UNITED STATES PATENT AND TRADEMARK OFFICE

Office Action Summary

10/646,929

DETAILED ACTION

FIG. 3

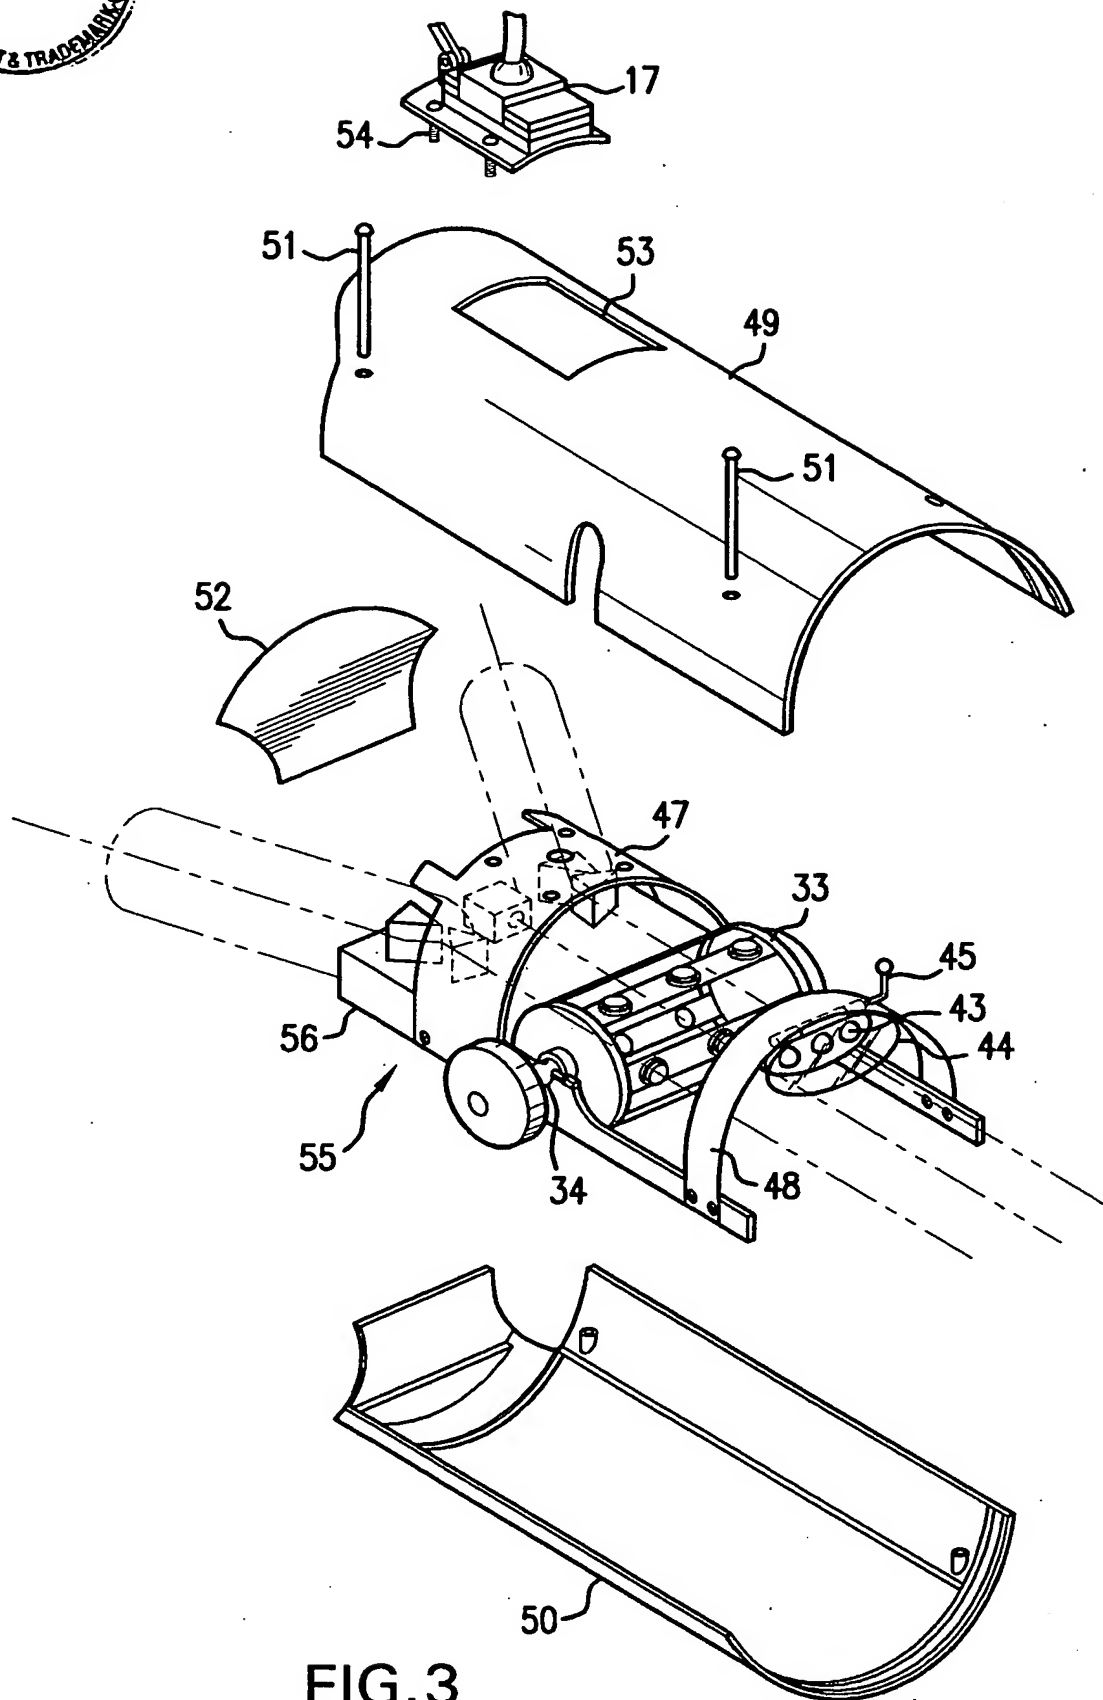
2. The drawing contains corrected figure 3 was received on 4/27/2004 and received one more time on 6/23/05. The corrected figure 3 has been approved by the Examiner.
